APPLICATION FOR A FLOOD CONTROL PERMIT WITHIN THE STATE OF SOUTH DAKOTA

SOUTH DAKOTA
FLOOD CONTROL PERMIT NO. FC-17

RE: Maintenance Project 0142-171 - Flood Control Permit
US 14A west of Volga

Report on Flood Control Permit Application No. FC-17
South Dakota Department of Transportation
February 7, 1996

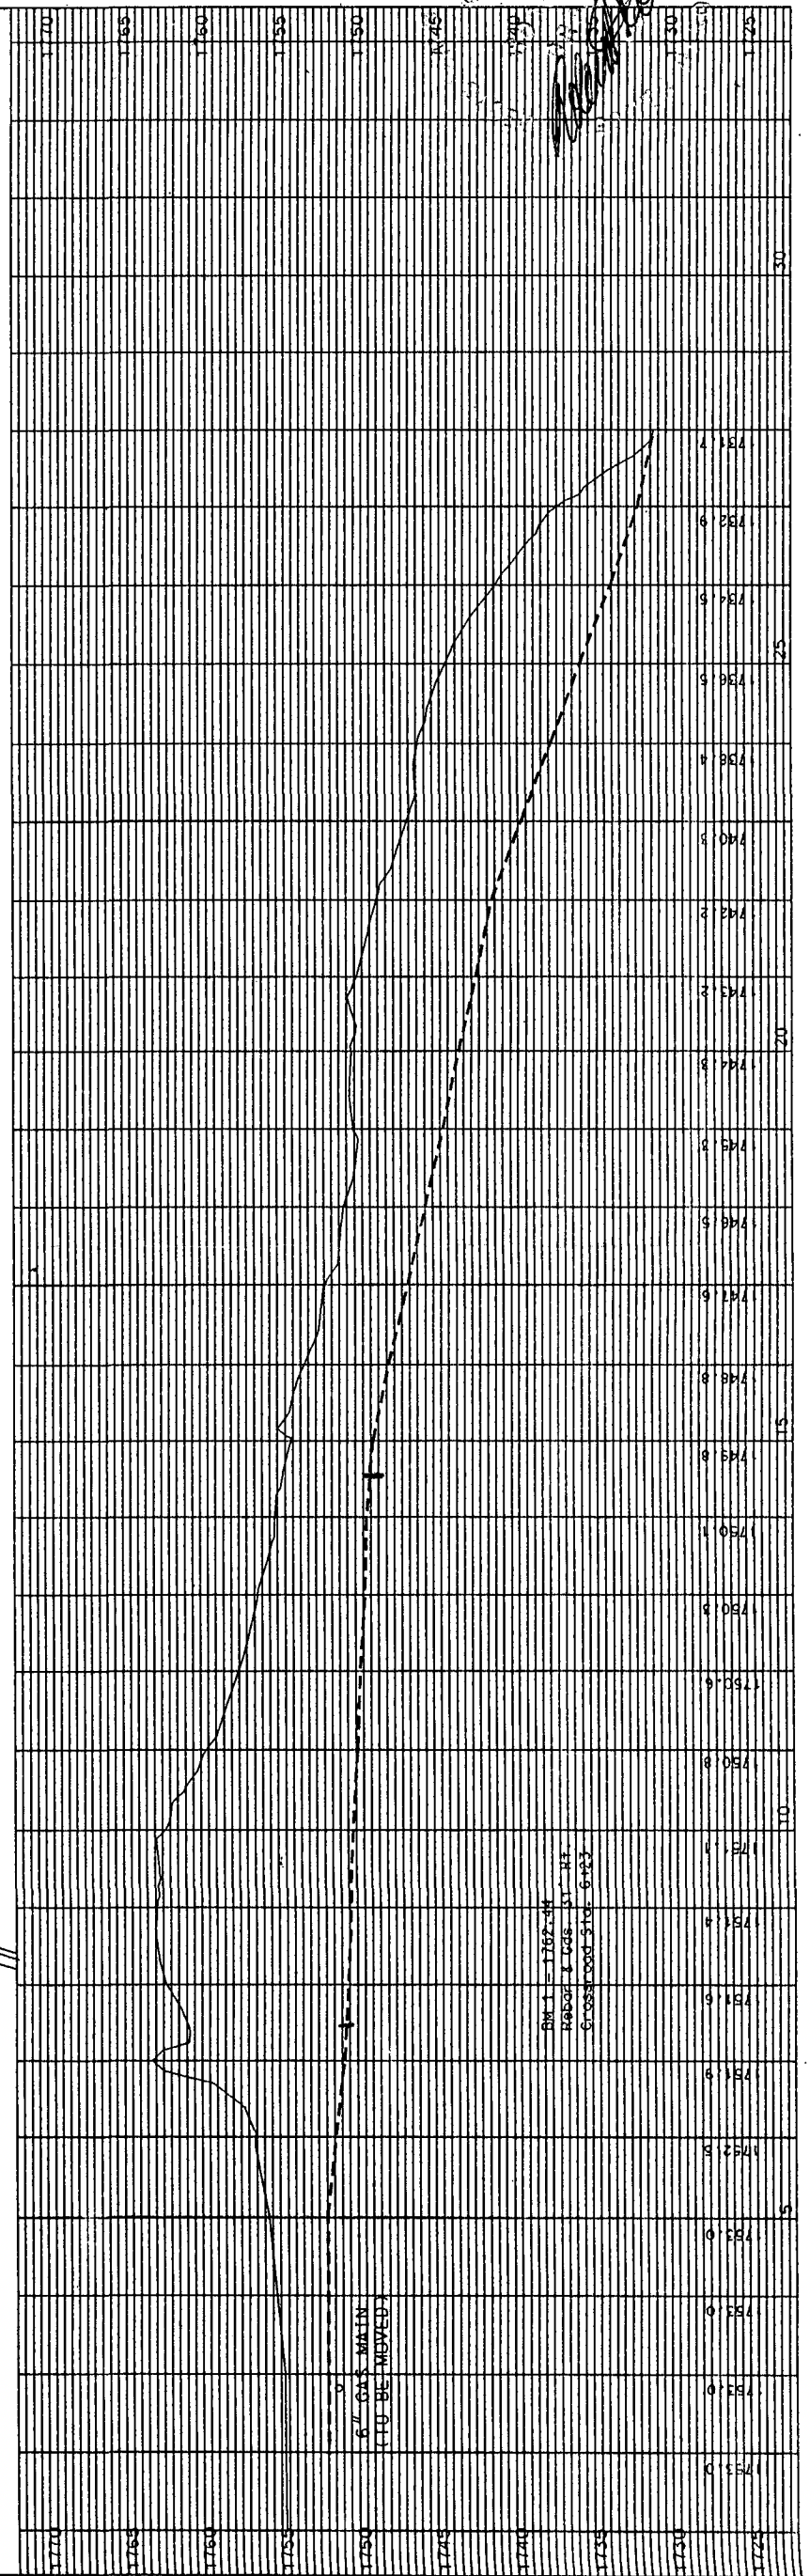
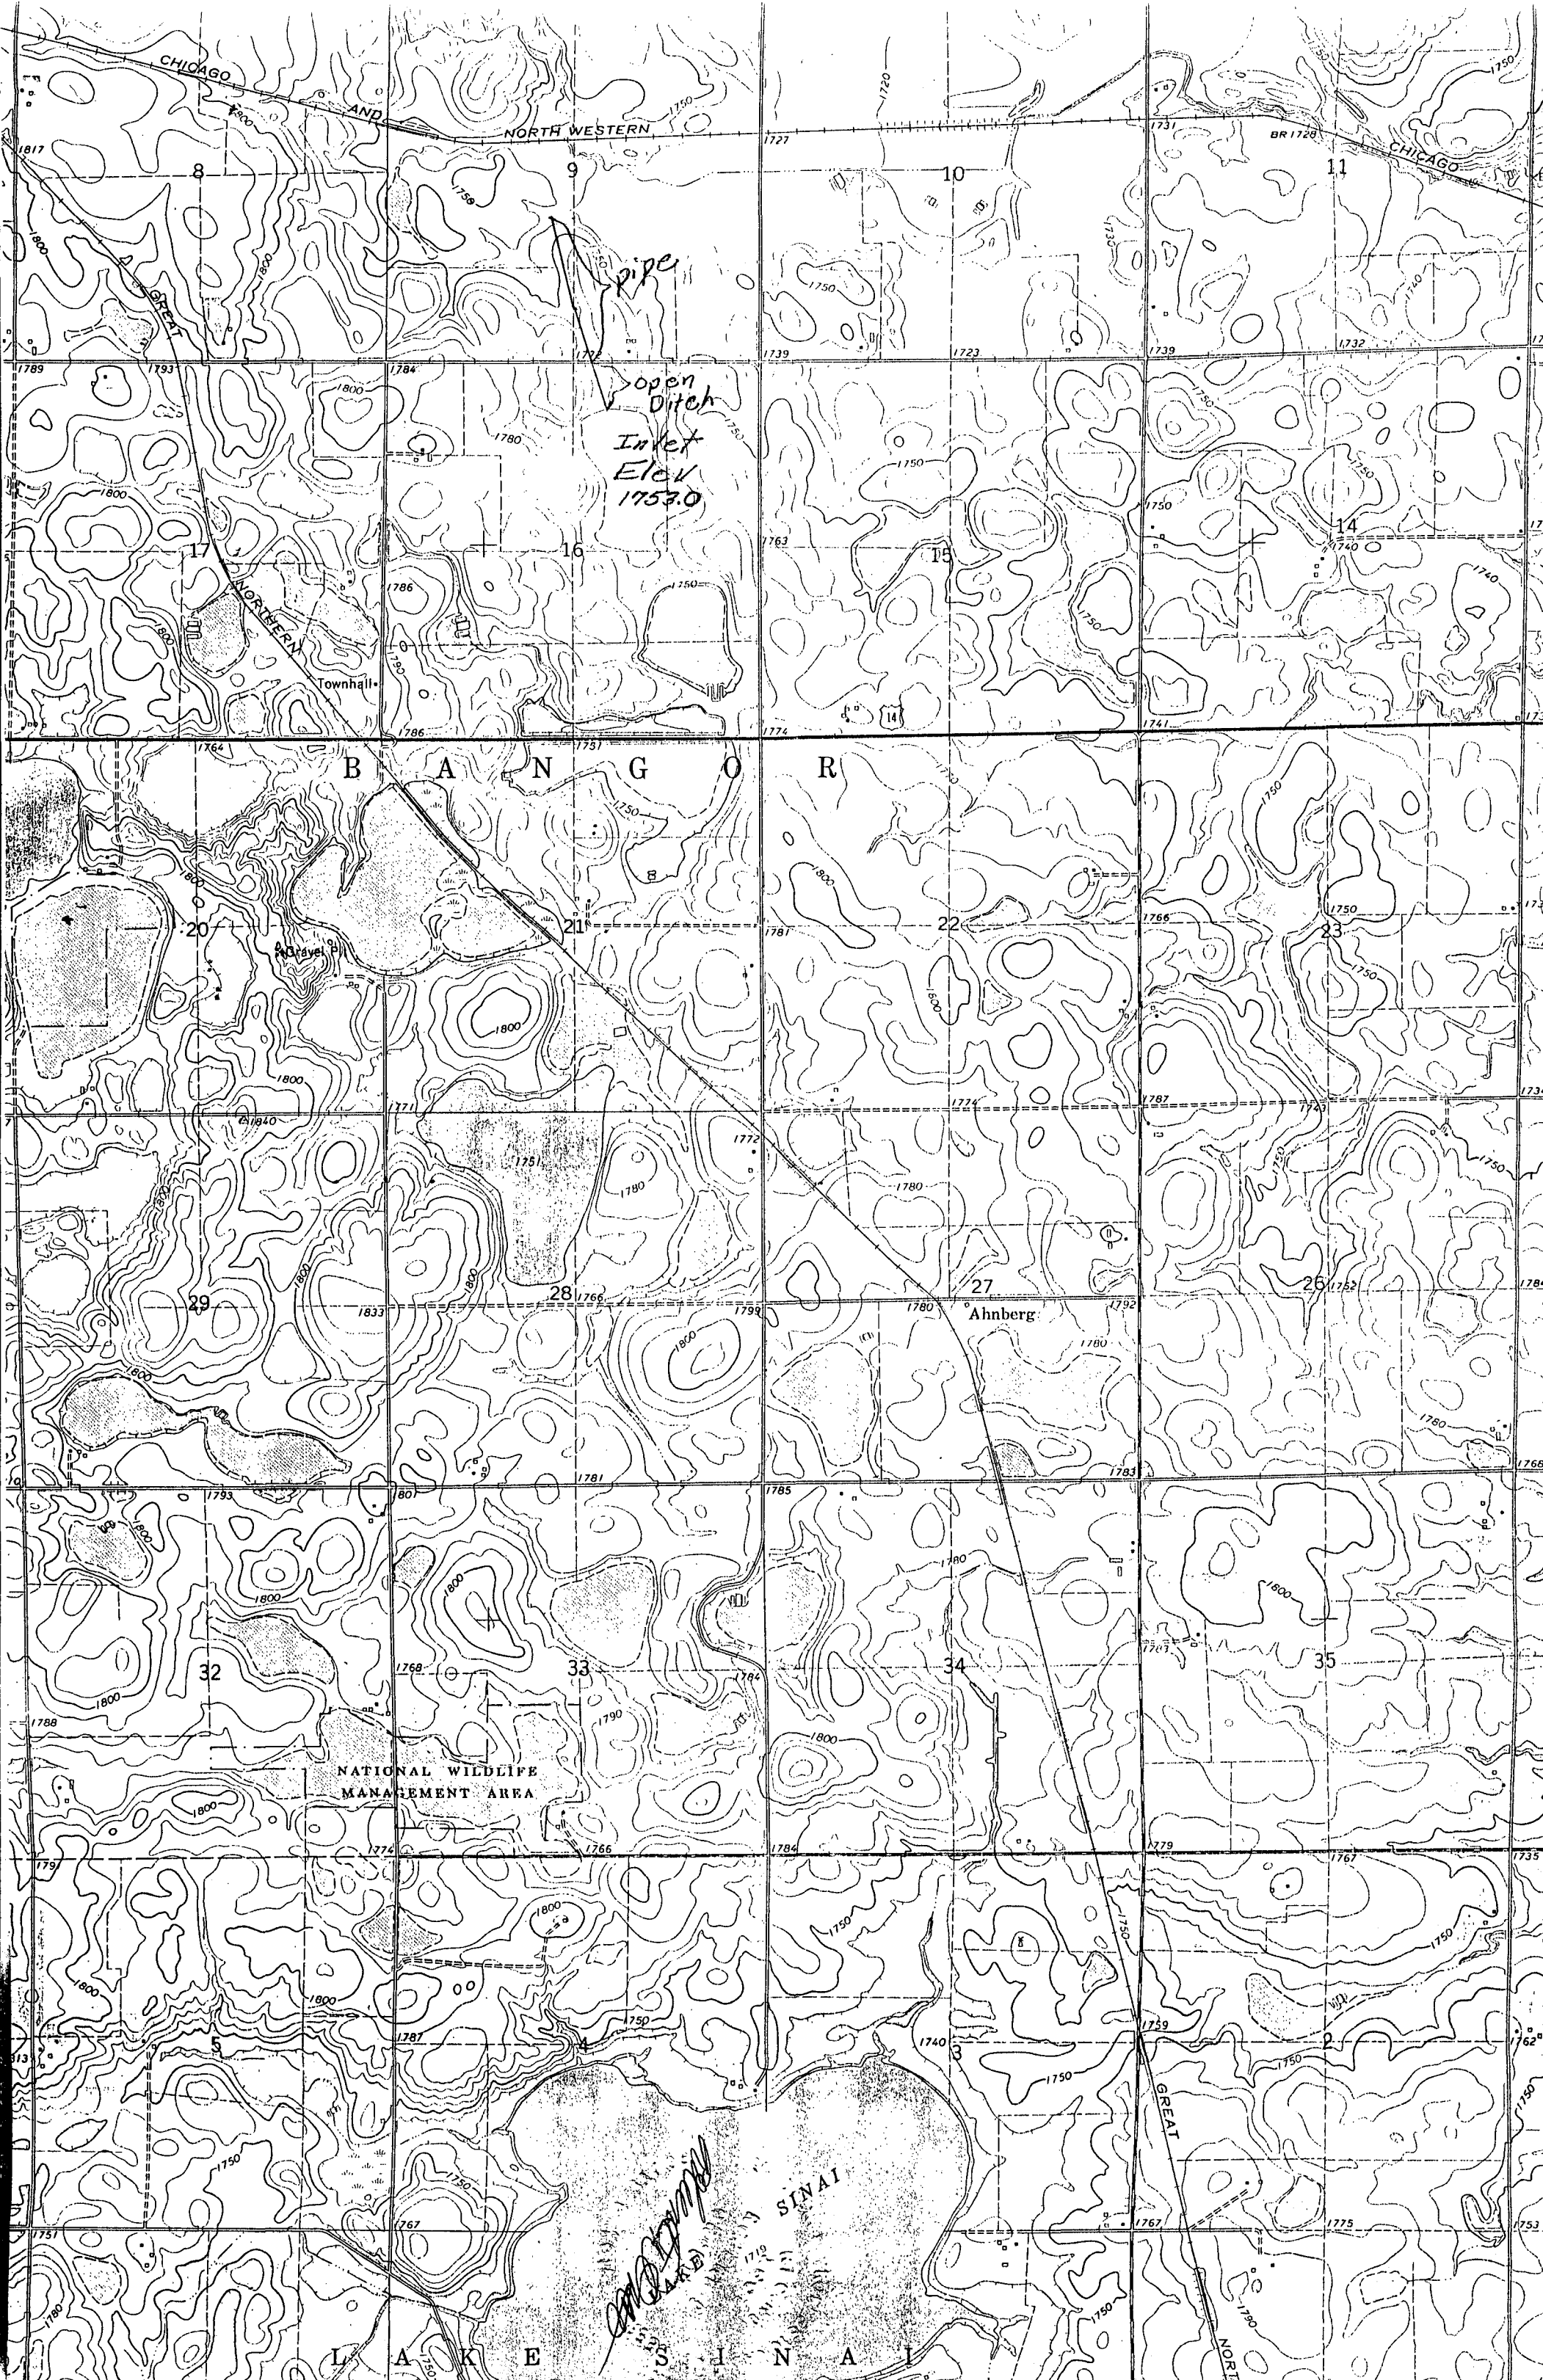
This office has completed the analysis of the proposed pipe size for the above referenced project as requested by the Aberdeen Regional Office. We reviewed the feasibility to reduce the 42 inch CMPA placed through the township road to an appropriate pipe size which would maintain maximum flow capacity.

It was determined that a reduction in the 42 inch pipe through the township road can be achieved and the following pipe configuration would be feasible:

The above configuration would meet or exceed the performance of the 42 inch CMPA and maintain a near full pipe flow throughout entire length of pipe. With the above pipe configuration, transition sections would be required for a change in pipe size from one size to another. Consulting with a corrugated metal pipe manufacture, reducer section of almost any configuration are possible. Manholes may be preferred over reducer sections at each pipe junction for aid in future inspection and cleanout of the pipeline.

With the reduction in the pipe size throughout the pipe line, there is a possibility of plugging to occur. To prevent possible plugging, placement of a trash rack at the inlet would catch large debris from entering into the pipeline and would prevent possible internal plugging of the proposed pipeline.

Sta 7+50+ to Sta 15+00	36 inch CMPA
Sta 15+00 to Sta 22+00	36 inch CMPA
Sta 22+00 to Sta 27+00	30 inch CMPA
Sta 27+00 to Sta 28+00	30 inch CMPA
